Agenda Item 3
730 Washington Road
New Residence – Revisions to Previously Approved Plans

TO:	Chairman Grieve and members of the Historic Preservation Commission
DATE:	August 25, 2021
FROM:	Jennifer Baehr, Planner
SUBJECT:	730 Washington Road – Revisions to Previously Approved Plans

Outline of Revisions

PREVIOUS TWO-STORY ITERATION:

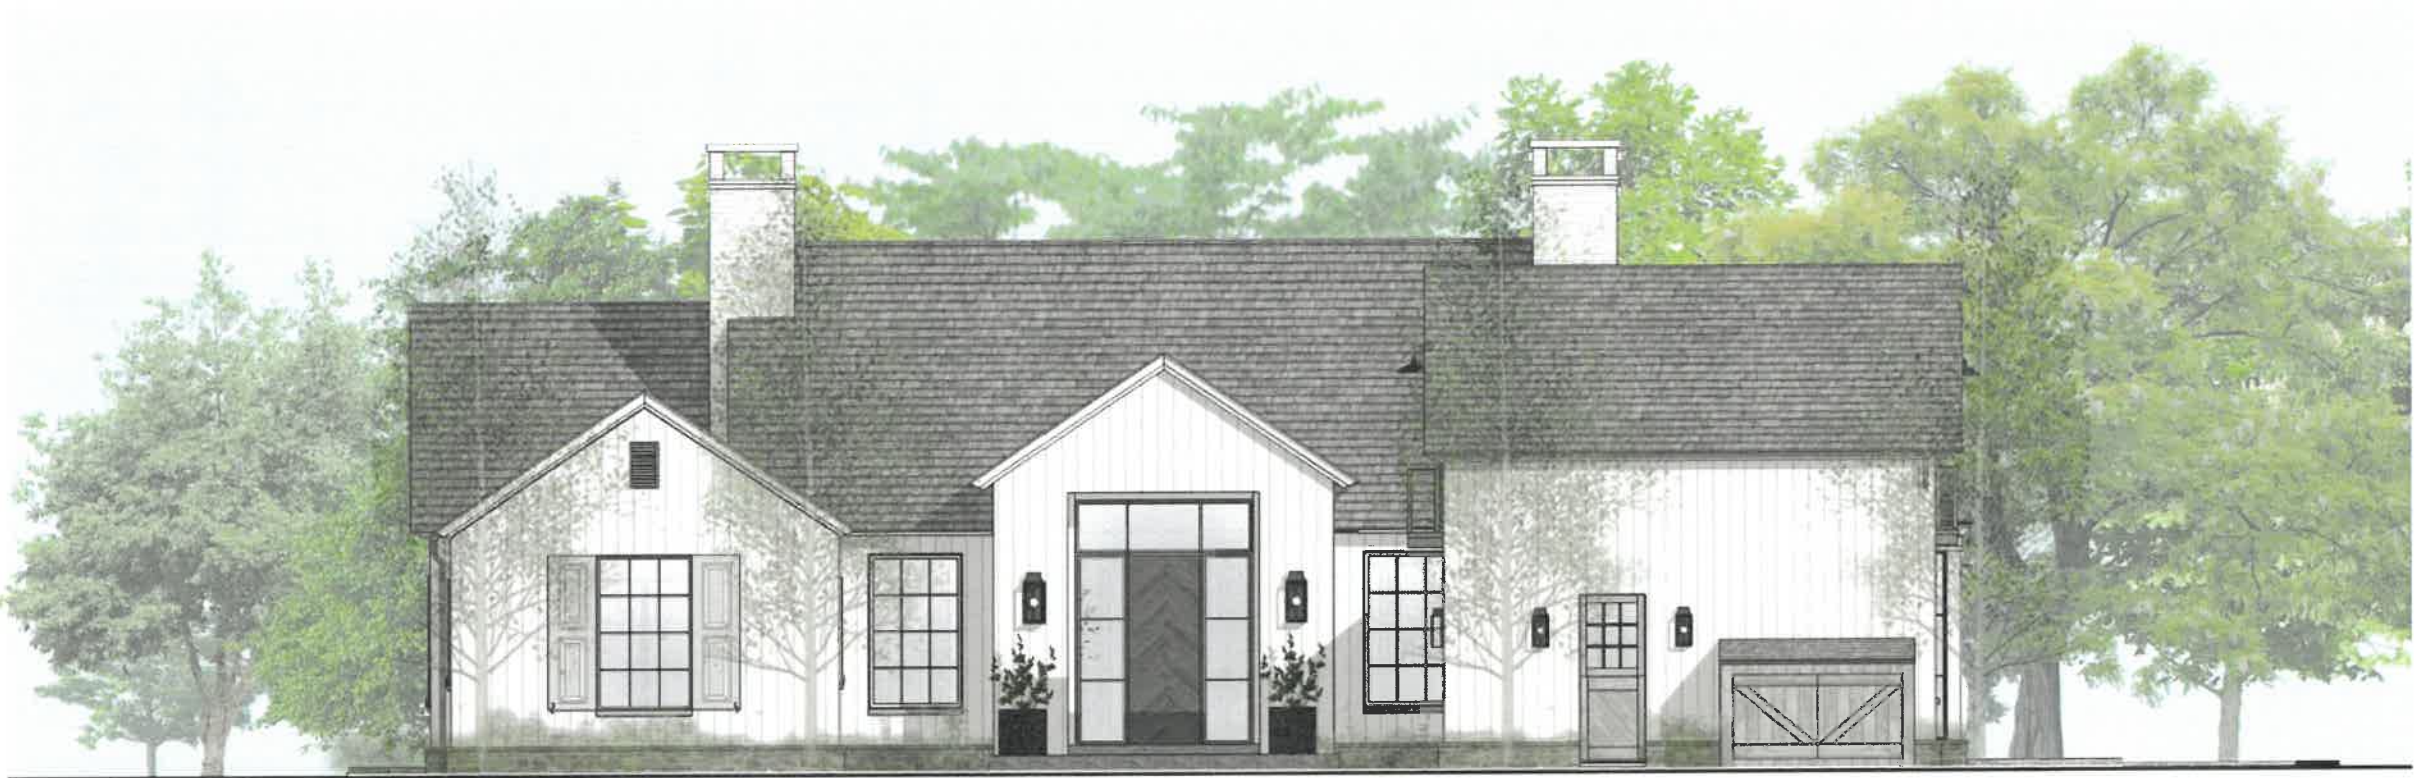
While developing the design of 770 Washington Road, it became clear that the house was larger than suited the needs of the client and there was no reasonable need for a finished second floor over the main house. This floor contained two en suite bedrooms. The third second floor en suite – over the garage – remains for a potential future live in care giver.

The tallest roof ridge was brought down 3'-5 1/2" to 30'-11 1/2" from 34'-5" tall (height to lowest adjacent existing grade). The height of the new ridge from proposed grade at the front door went down to 25'-5 1/2" from 28'-11"

The bay window at the garden side of the main living area was removed – this allows a central circulation path through the house to the courtyard while allowing better furniture placement in the combined living room and dining room space. While improving flow from the interior to the courtyard, the elimination of the bay also freed up more space to allow for a comfortable outdoor seating area nestled between the wings of the house.

While we diminished the height of the main volume of the house, we wanted to be sure that the front door had proper prominence as the main entrance to the house. We increased the height of the entry porch and allowed the entry volume to break the eave line of the main house roof.
